NACELLE - POWER PLANT - EEC COOLING - SUPPORT BRACKETS - REMOVAL/REPLACEMENT OF -
CATEGORY CODE 3 - MOD.ENG-71-0070

V2500-ENG-71-0070

The EEC and ignition supply harness is rerouted slightly due to the removal of the EEC cooling. Three support brackets are removed and another is replaced. Two clipping points are removed and replaced by a single clipping point.

Removal of Fancase Harness and EEC Cooling Support Brackets Fig.1

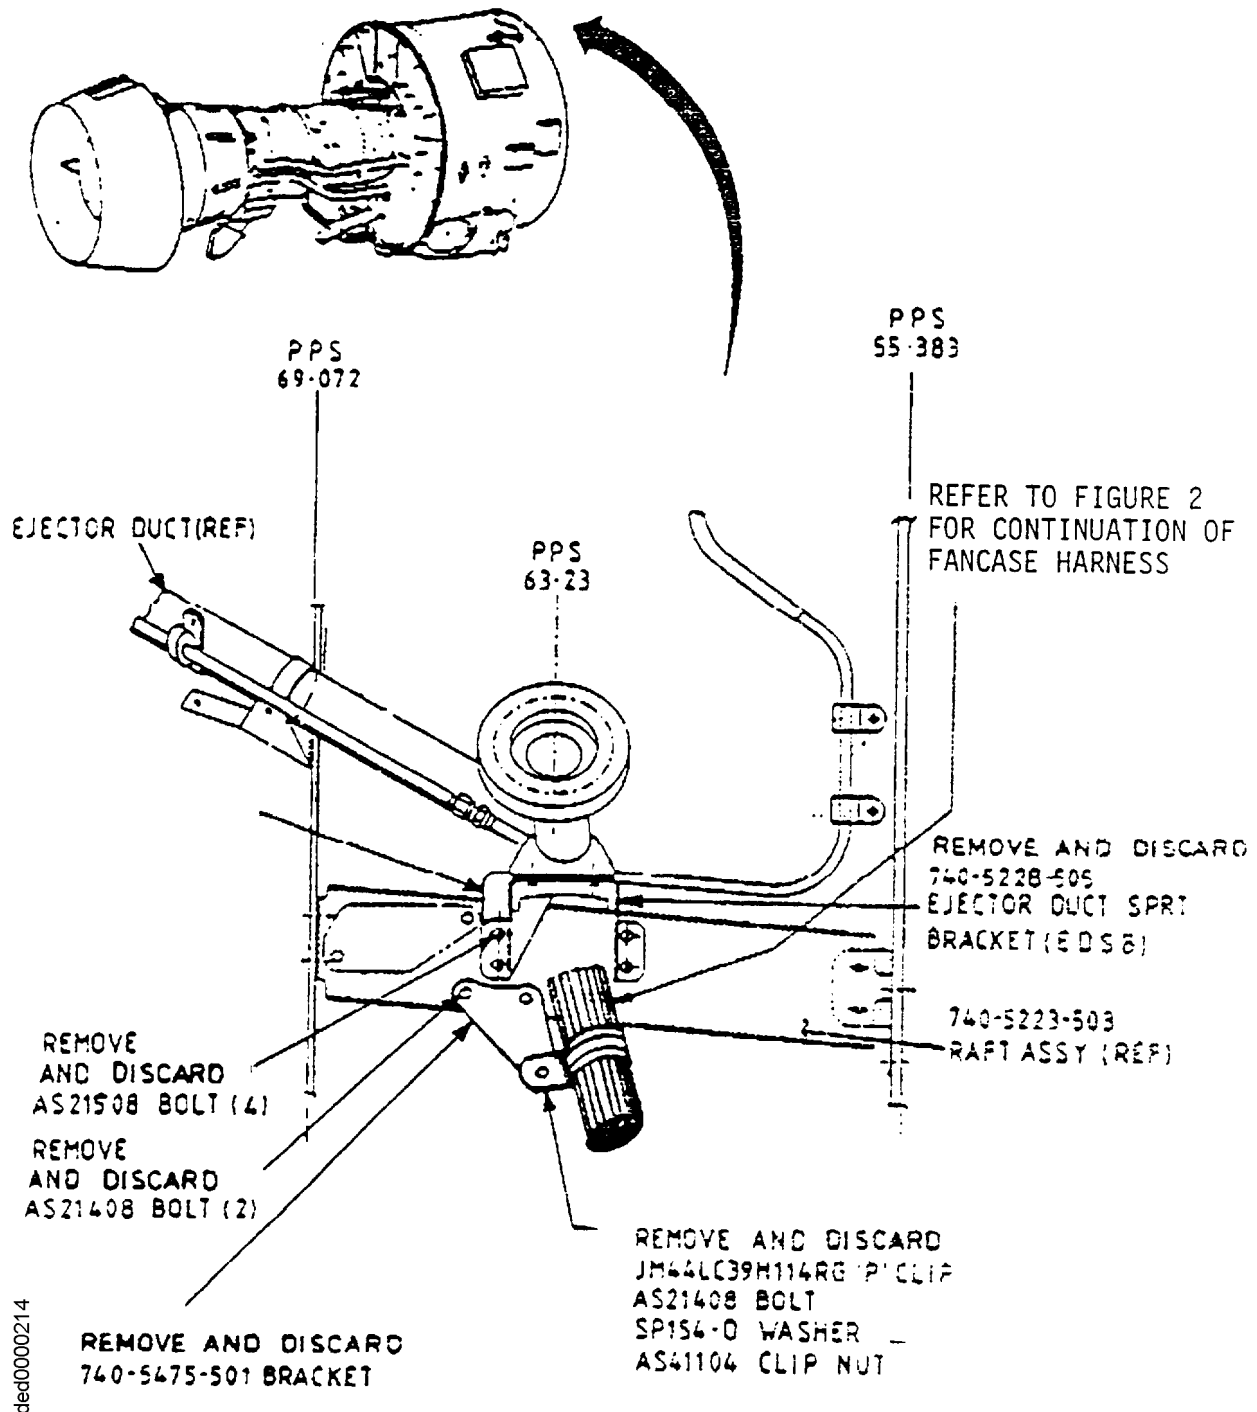
- (1) Remove four AS21058 bolts to release the 740-5228-505 ejector duct support bracket. (Refer to Figure 1.) Discard the bracket and the bolts.
- (2) Remove the JM44LC39H114G 'P' clip, AS21408 bolt, SP154-D washer, and AS41104 clip nut from the 740-5475-501 bracket. Discard the 'P' clip, bolt, washer, and clip nut.

Removal of Fancase Harness and EEC Cooling Support Brackets
Fig.2

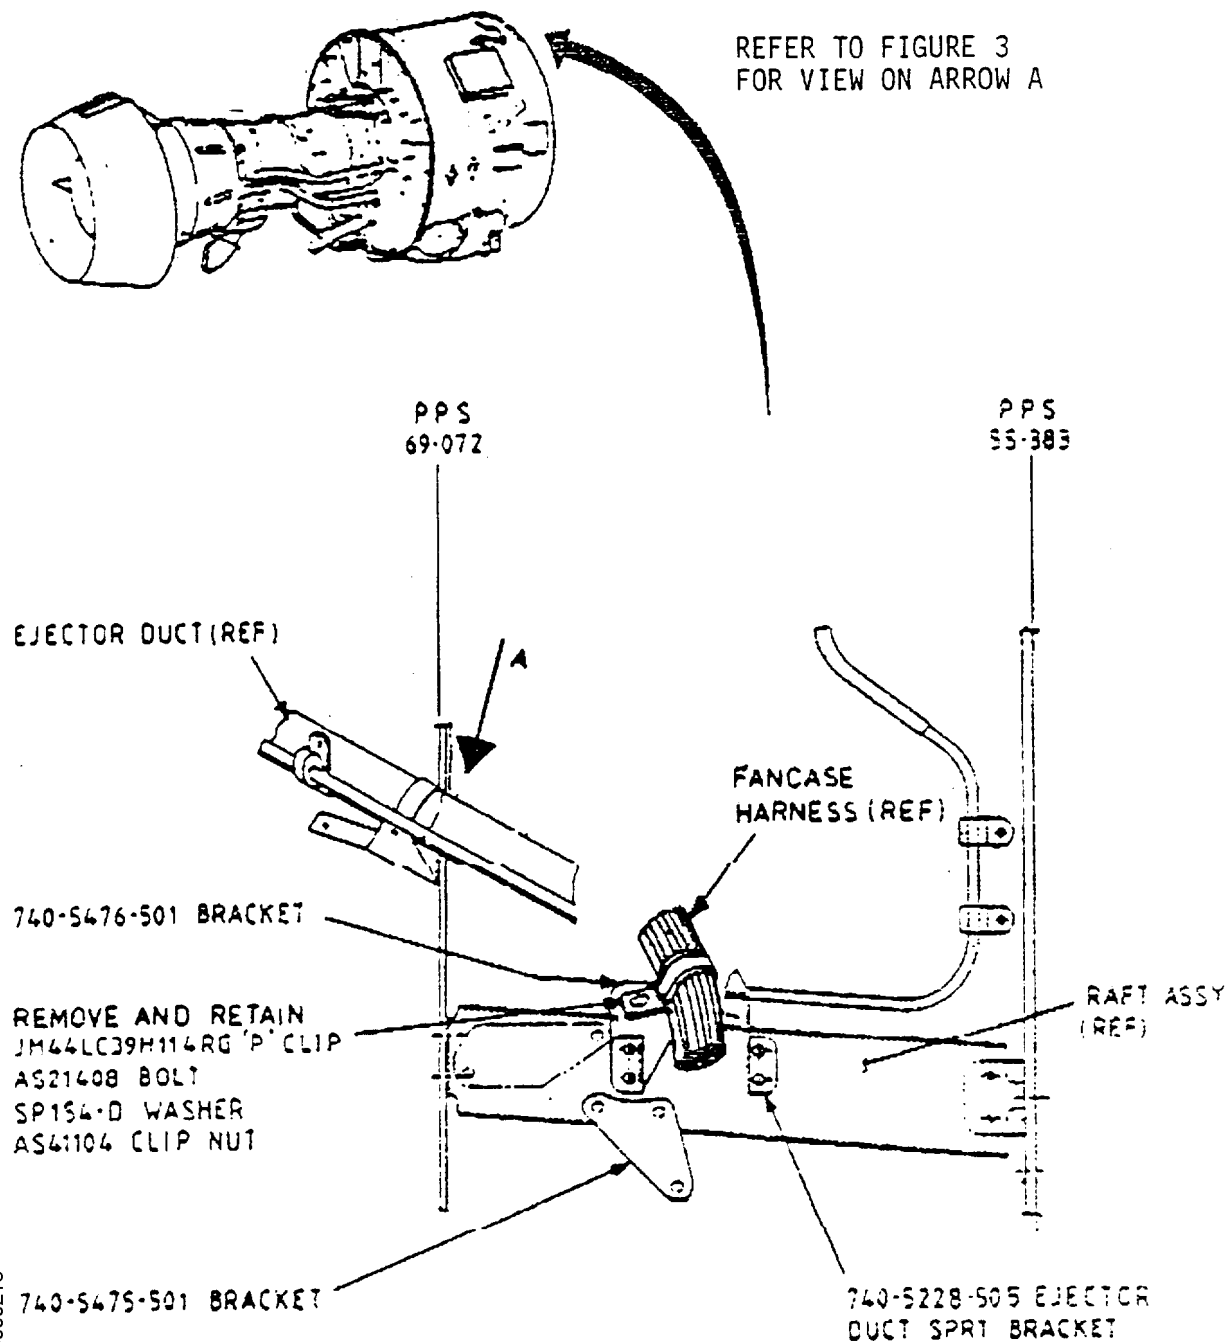
- (3) Remove two AS21408 bolts to release the 740-5475-501 bracket. Discard the bracket and the bolts.
- (4) Remove the JM44LC39H114RG 'P' CLIP, AS21408 bolt, SP154-D washer, and AS41104 clip nut from the 740-5476-501 bracket. (Refer to Figure 2.) Discard the bracket and clip nut. Keep the bolt, washer, and 'P' clip.

Attachment of the Fancase Harness to the Raft Assembly
Fig.3

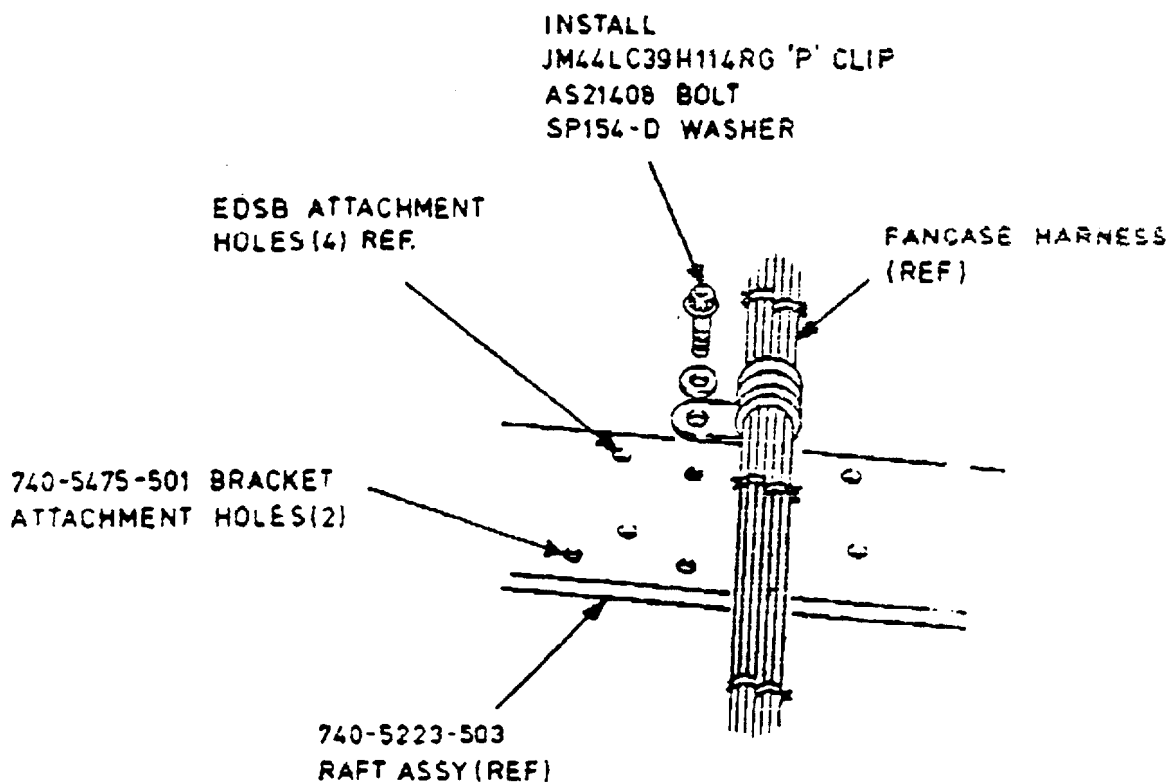
- (5) Attach the fancase harness to the 740-5223-503 aft assembly (where shown) with the JM44LC39H114RG 'P' clip, SP154-D washer, and AS21408 bolt (retained in paragraph 2.B.(4)). Torque tighten to 40 lb-in. (4.52 N.m). (Refer to Figure 3.)

NOTE: DO NOT USE THE ATTACHMENT HOLES
OF THE EDSB OR 740-5471-501 BRACKET

Replacement of Support Bracket
Fig.4

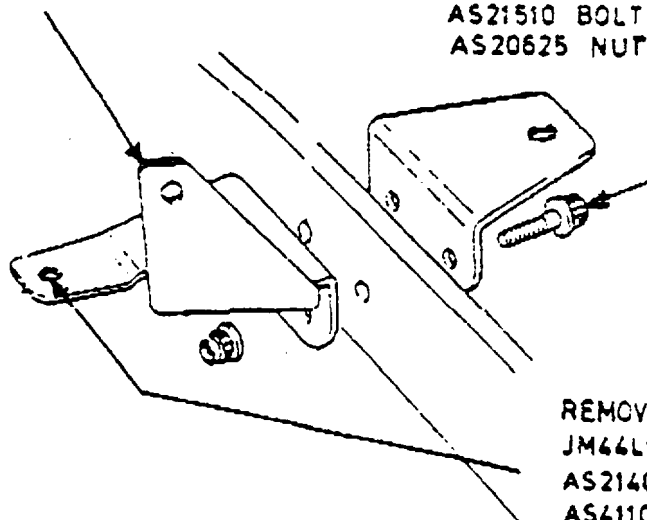
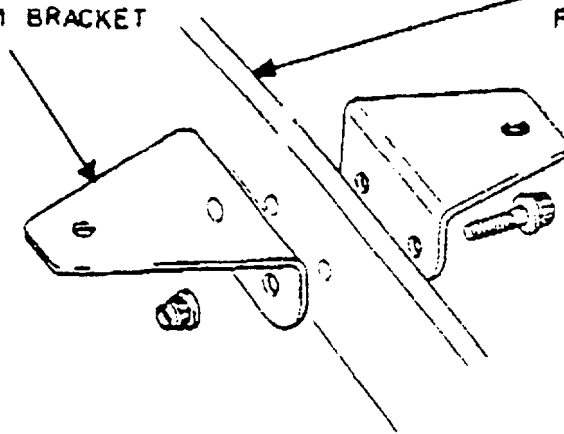
- (6) Remove and retain the JM44LC39H108 'P' clip, AS21408 bolt, AS1104 nut, and SP154-D washer from the 740-5229-501 bracket as shown. (Ref to Figure 4.)

- (7) Remove two AS21510 bolts and two AS20625 nuts to release the 740-5229501 bracket. Discard the bracket.
- (8) Install a new 740-5429-501 bracket (to the flange at PPS 69.072) as shown with the two AS21510 bolts and two AS20625 nuts retained in paragraph 2.B.(7). Install the other 740-54290501 bracket back to the flange at the same time. Torque tighten the nuts to 100 lb-in. (11.3 N.m).

REMOVE AND DISCARD
740-5229-501 BRACKET

REMOVE AND INSTALL
AS21510 BOLT (2)
AS20625 NUT (2)

REMOVE AND INSTALL
JM44LC39H108 P CLIP
AS21408 BOLT
AS41104 NUT
SP154-D WASHER

INSTALL
740-5429-501 BRACKET

- (9) Attach the fancase harness to the new 740-5429-501 bracket with the JM44LC39H108 'P' CLIP, AS21408 bolt, AS41104 nut, and SP154-D washer removed in paragraph 2.B. (6). Torque tighten to 40 lb-in. (4.52 N.m).
